GEW39-11

603.1.1.1

603.1.1-SWIECICKI-BEAUREGARD

FIGURE 611.4 PHOTOVOLTAIC RESOURCE MAP (kWh/m²/day)

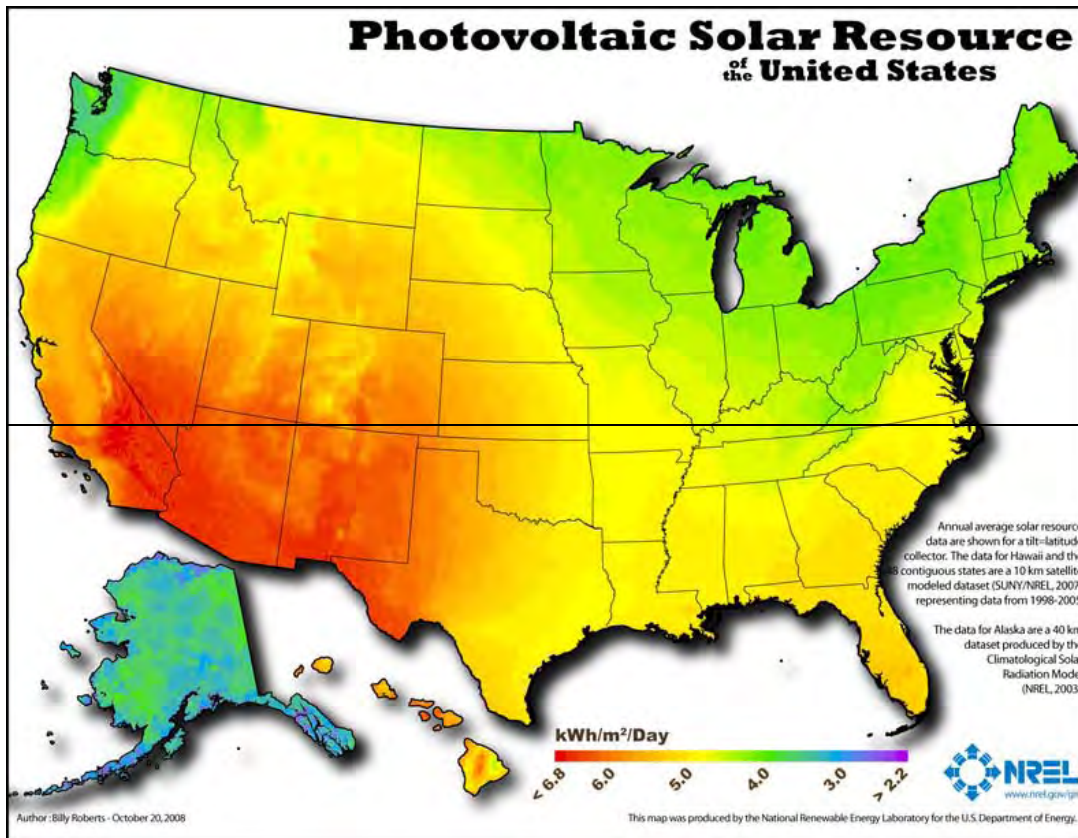
Delete without substitution:

Reason: It doesn't appear Figure 611.4 is referenced in the text of IGCC Public Version 2.0 and, therefore, the figure doesn't appear to be applicable and should be omitted.

Figure 202.1
Daylight Zone Adjacent to Vertical Fenestration in a Wall

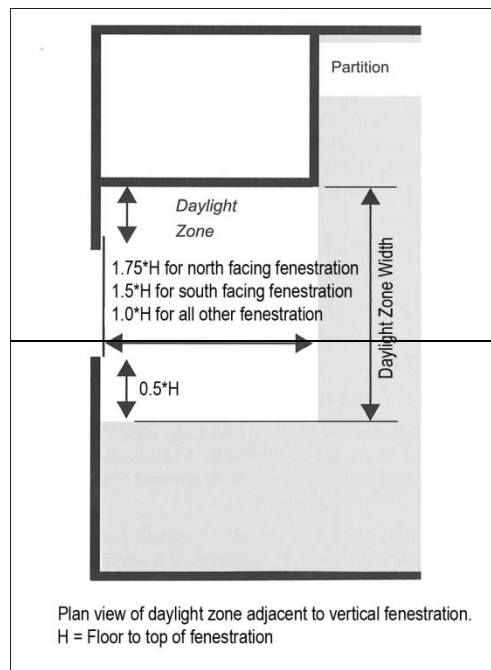
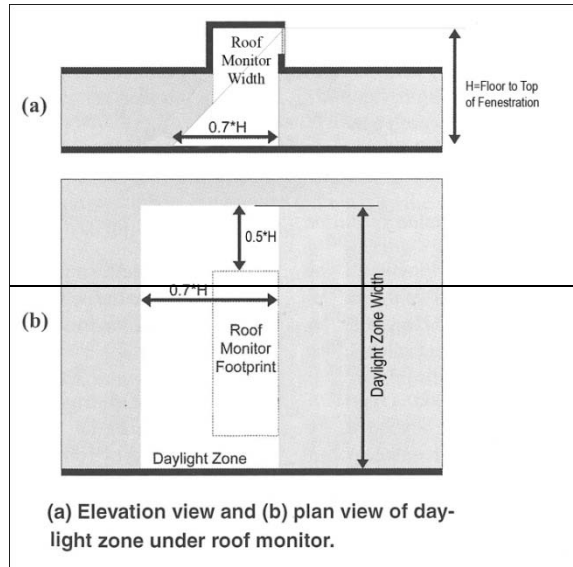
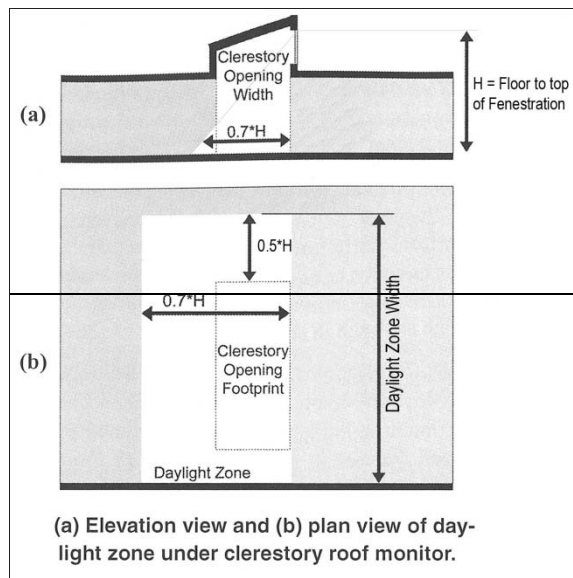
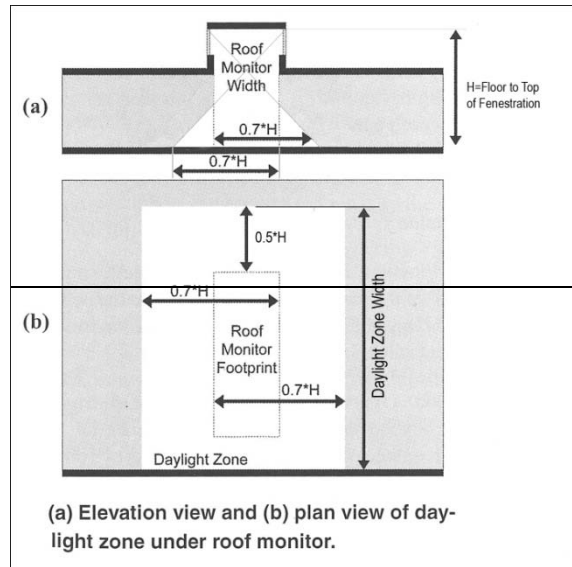
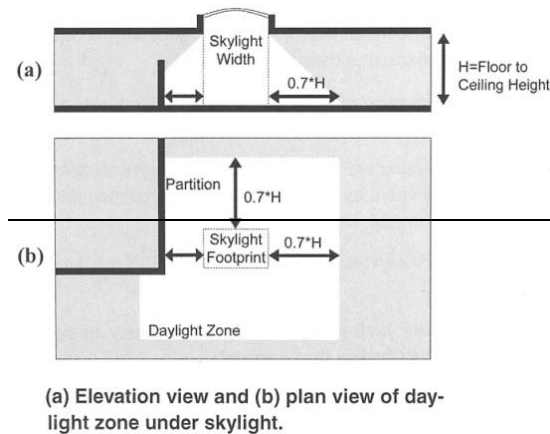
Delete definitions and figures without substitution:

Figure 808.1
Daylit Area Adjacent to Fenestration in a Wall

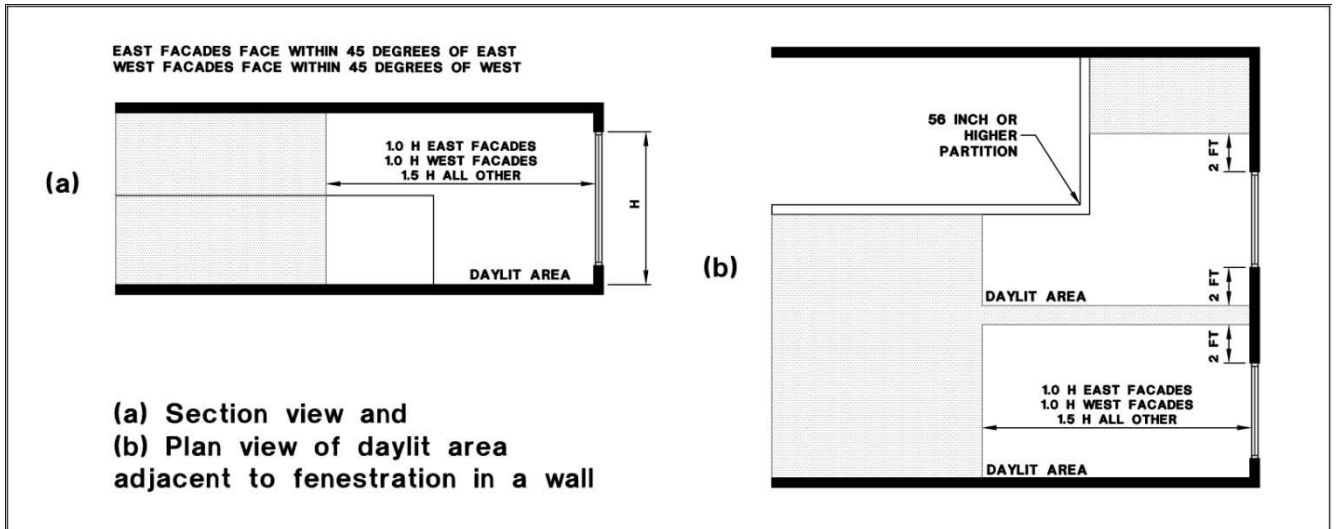
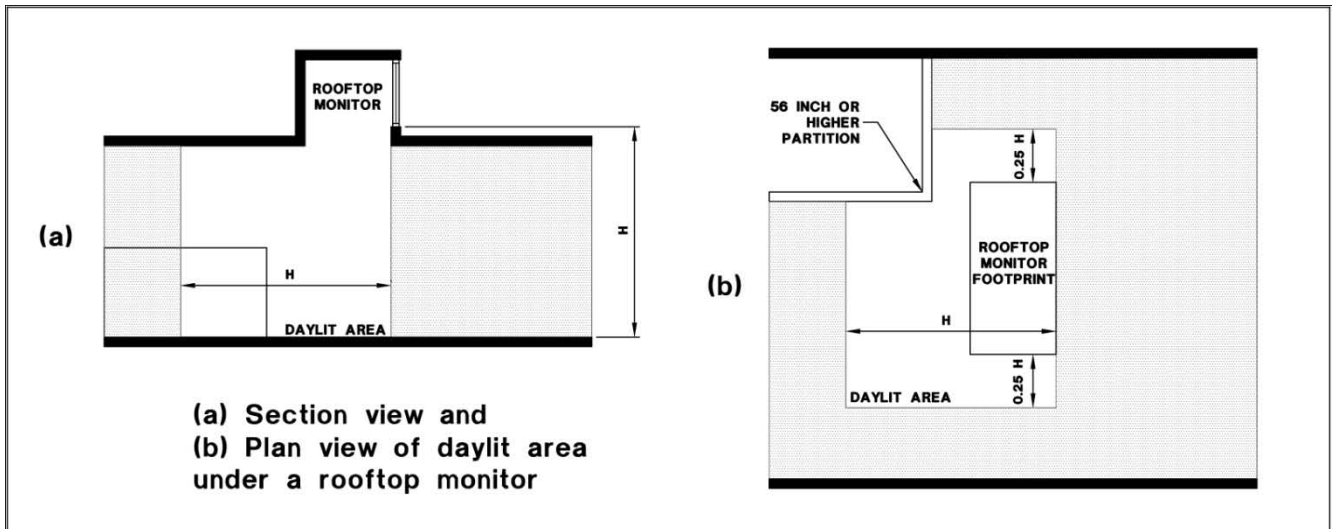
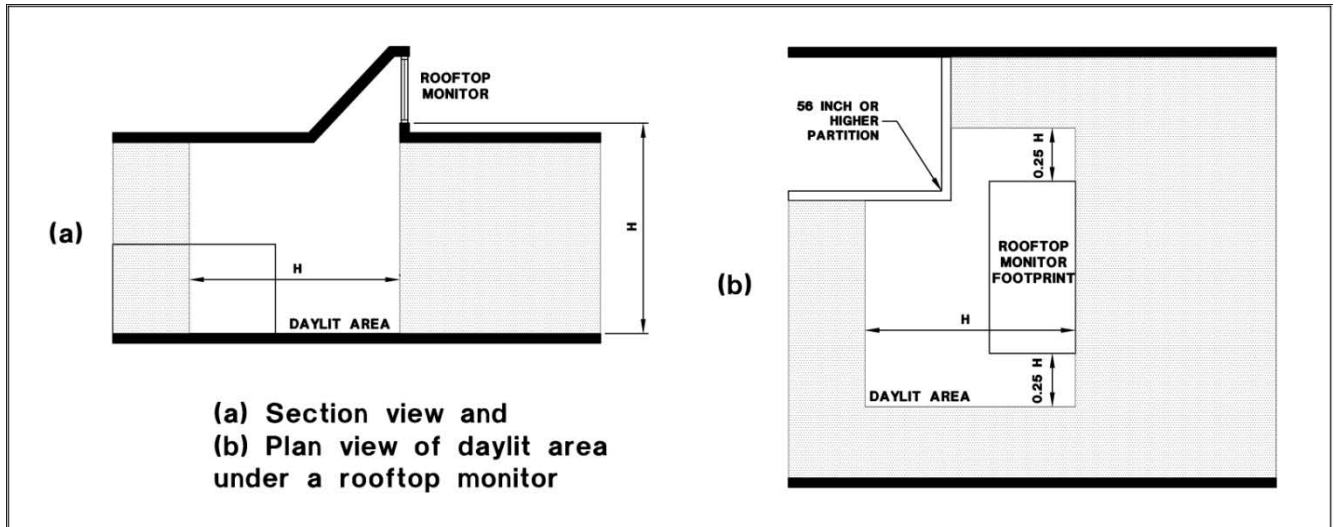
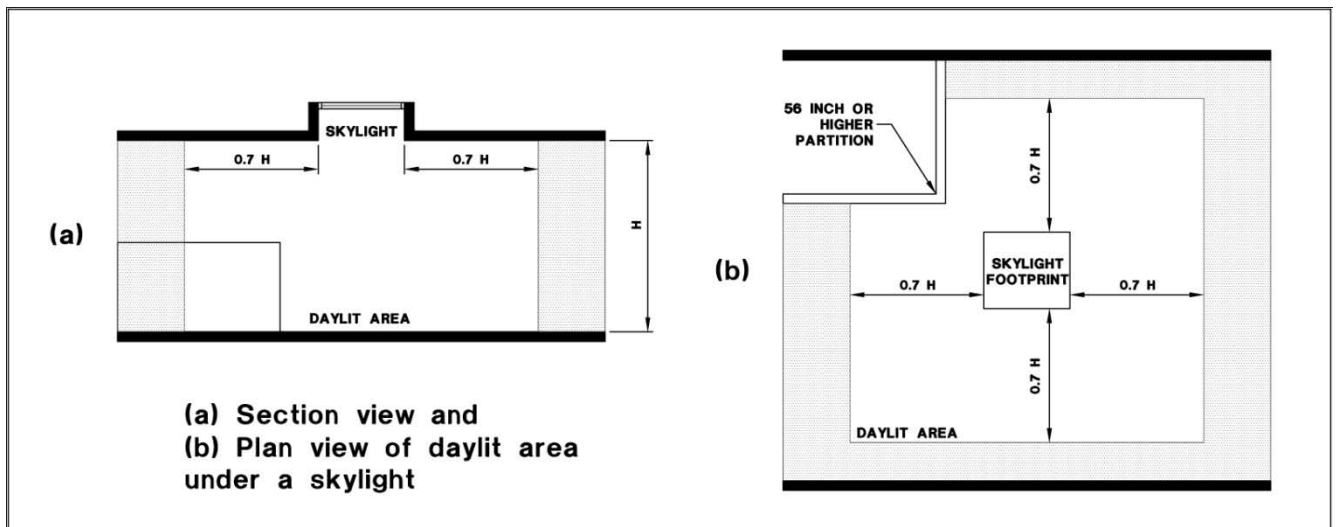
808.2.2. Sidelighting. The daylight area shall be illuminated by fenestration that complies with Table 808.1 and Figure 808.1.

808.2.2.1 Sidelighting daylight area. Where fenestration is located in a wall, the daylight area shall extend laterally to the nearest 56 inch high partition, or up to 1.0 times the height from the floor to the top of fenestration facing within 45 degrees of east or west or up to 1.5 times the height from the floor to the top of all other fenestration, whichever is less, and longitudinally from the edge of the fenestration to the nearest 56 inch high partition, or up to 2 feet, whichever is less, as indicated in Figure 808.1. Where fenestration is located in a rooftop monitor, the daylight area shall extend laterally to the nearest 56 inch high partition, or up to 1.0 times the height from the floor to the bottom of the fenestration, whichever is less, and longitudinally from the edge of the fenestration to the nearest 56 inch high partition, or up to 0.25 times the height from the floor to the bottom of the fenestration, whichever is less, as indicated in Figures 808.2 and 808.3.

808.2.3 Toplighting. The *daylit area* shall be illuminated by a *skylight* that complies with Table 808.1 and Figures 808.2 to 808.4.

808.2.3.1 Toplighting daylit area. The *daylit area* extends laterally and longitudinally beyond the rough opening of the *skylight* to the nearest 56 inch high partition, or up to 0.7 times the height from the floor to the bottom of the rough opening of the *skylight* well, whichever is less, as indicated in Figure 808.4.
